**Sydney Development Control Plan 2012
55 Pitt Street, Sydney amendment**

Sydney Development Control Plan 2012 – 55 Pitt Street, Sydney

March 2020

APDG Site - Public domain plan (Option B)

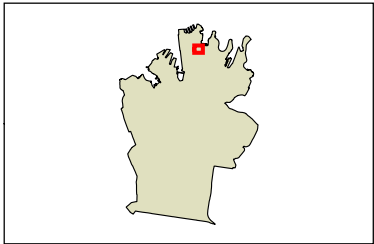
Replace Figure 6.7A as shown attached

APDG Site - Alternate heights (Option B)

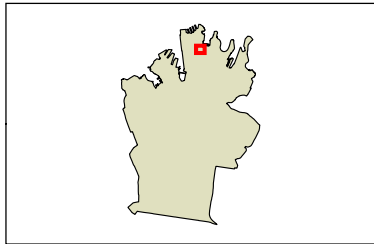
- (i) Pitt Street – 6m at the northeast corner of the tower, transitioning to 4m at the southeast corner of the tower;
- (ii) Underwood Street – 3m at the western corner of the tower, stepping to 4m at the eastern corner of the tower; and
- (iii) Queens Court (future through-site link) – 1m above RL 47.7m as shown in figure 6.10A Alternative heights Option B.

- (5) *For block 4 introduce a new commercial tower on the eastern side of block 4 as identified in Figure 6.10A Alternative heights Option B.*
- (5A) For block 5 introduce a new commercial tower on the eastern side of block 5 as identified in Figure 6.10A Alternative heights Option B.

(11) For block 5, the new commercial tower shall include an allowance for façade articulation equivalent to 1% of the building envelope established in Figure 6.10A Alternative Heights Option B.

(c) Any additional floor space pursued for a building demonstrating design excellence under clause 6.21(7)(b), is to be accommodated within the building envelope shown in Figure 6.10A Alternative Heights Option B.

Replace Figure 6.10A as shown attached

APDG Site - Development blocks (Option B)

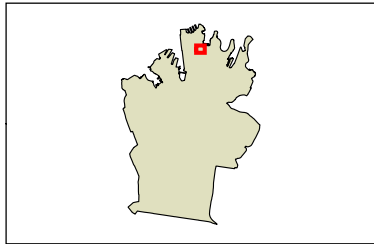
(a) An invited architectural design competition is to be undertaken in accordance with clause 6.21 of Sydney LEP 2012 for the entire site identified as block 5 in Figure 6.11A – APDG Site – Development blocks Option B.

Replace Figure 6.11A as shown attached

APDG Site - Setback above the street frontage height (Option B)

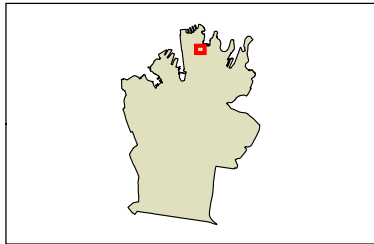
(e) the south-eastern tower on block 5:

Replace Figure 6.14A as shown attached

Figure 6.18a
North-west View
Development
Control Envelope
– 55 Pitt Street

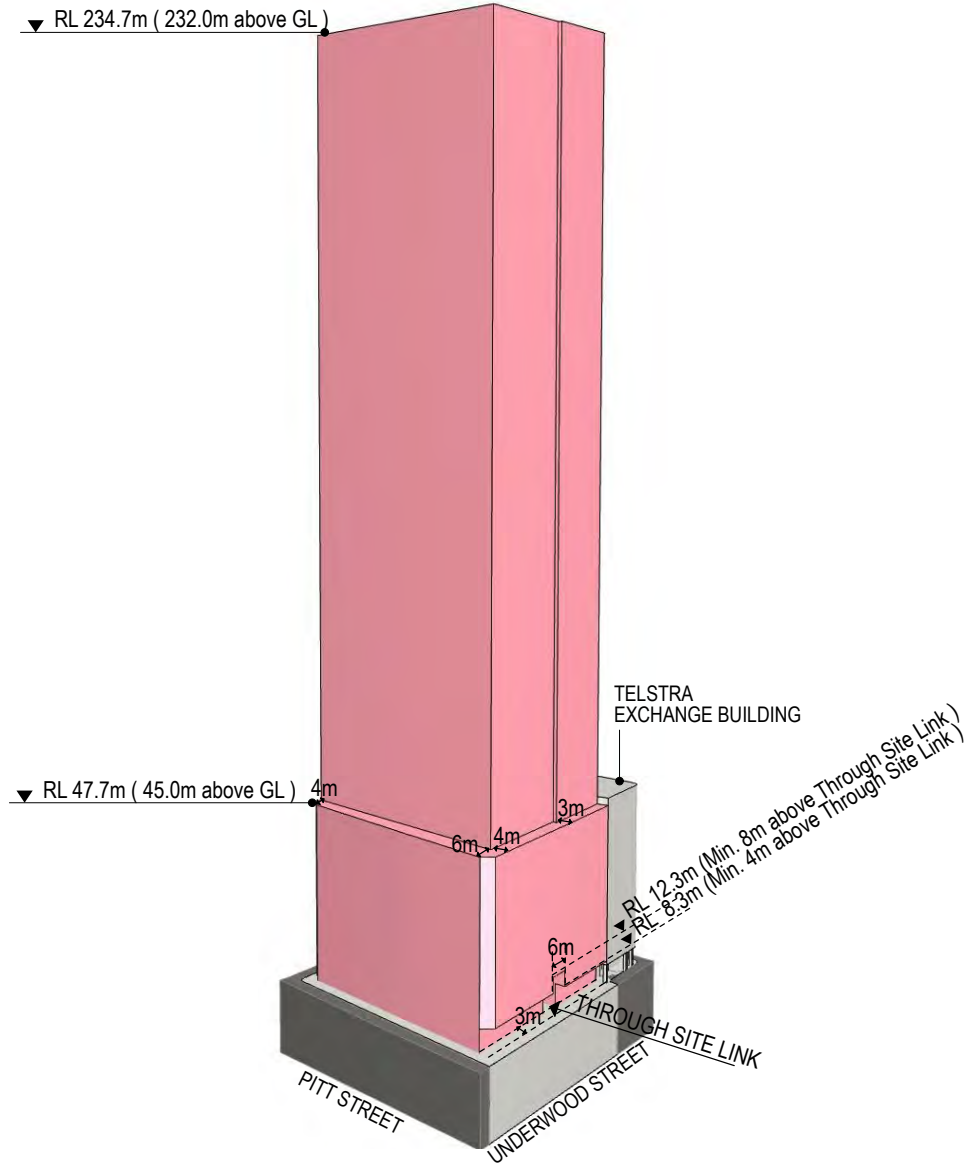
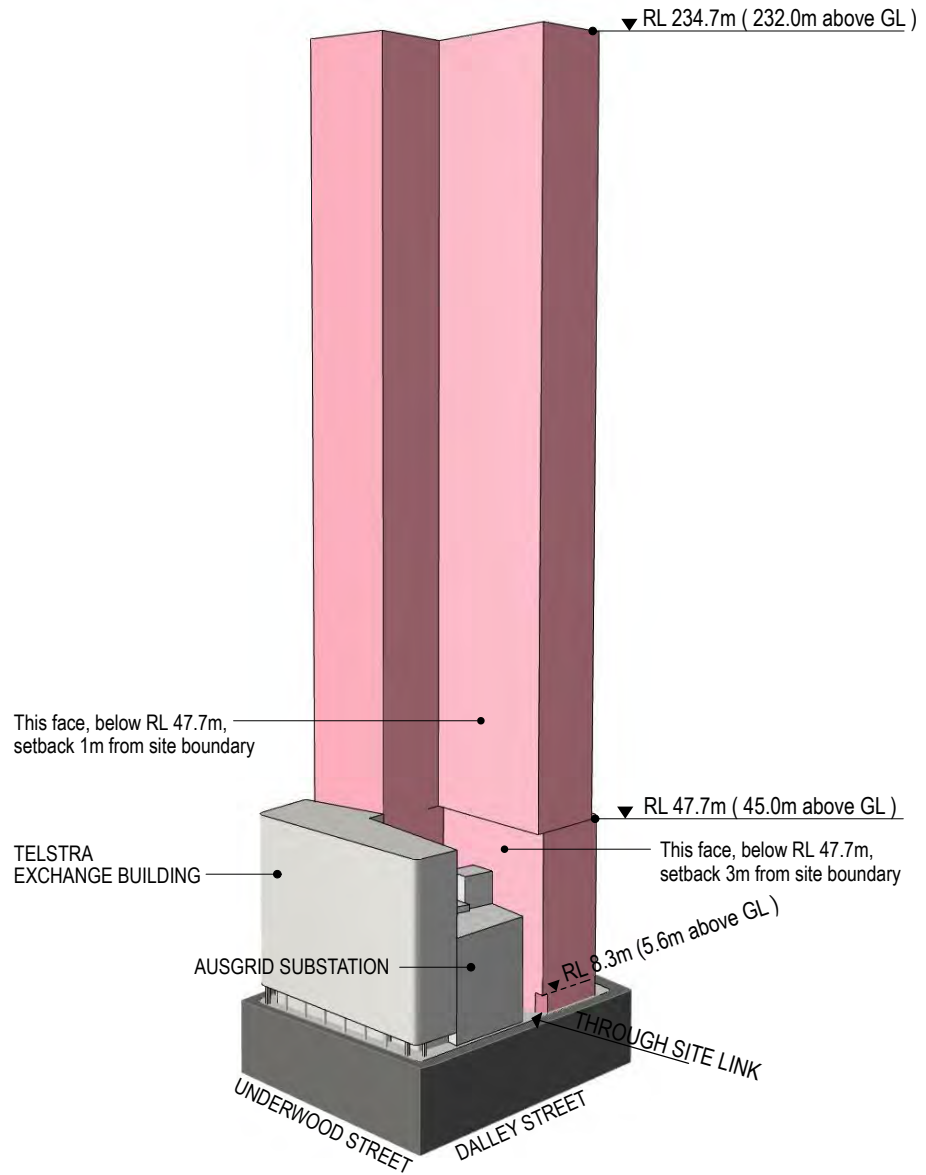
Inset new Figure – Development Control Envelope – 55 Pitt Street
